18 Forbes Street, Liverpool
New Liverpool Primary School

Submitted to Department of Planning, Industry and Environment
On behalf of Health Infrastructure NSW

12 November 2021 | 2190413

Figure 1 Unencumbered area for Liverpool Boys and Girls High School and NLPs

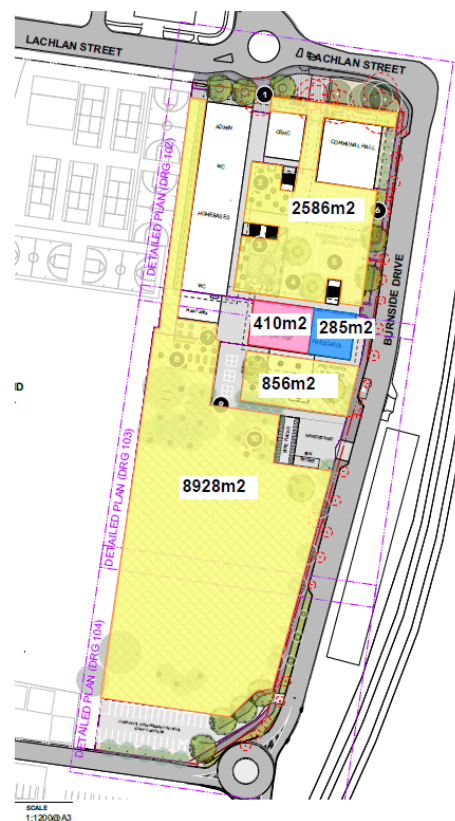
In their correspondence, the Department queried the amount of open space provided for both the new primary school and the adjacent Liverpool Boys and Girls High Schools. Further, the Department requested a breakdown of the amount of open space for each of the different schools, and the compliance with the Department of Education's Educational Facilities Standards and Guidelines (EFSG) requirement of 10m² of unencumbered play space per student.

The New Liverpool Primary School (NLPS) provides 12,800m² of unencumbered play space, which has been designed by landscape architects Spackman Mossop Michaels to provide a variety of places for active and passive play, social interaction and outdoor learning within the courtyard central to the school building, as well as a large open play area to the south sized to accommodate a full-sized soccer field.

- Primary School: 12,000m² = 10m² per student
- Support Unit: 400m² = 10m² per student
- Preschool: 285m² = 7m² per student
- High School: 23,000m² = 13m² per student

A diagram of the unencumbered play space is provided at **Figure 1** to clarify area allocations.
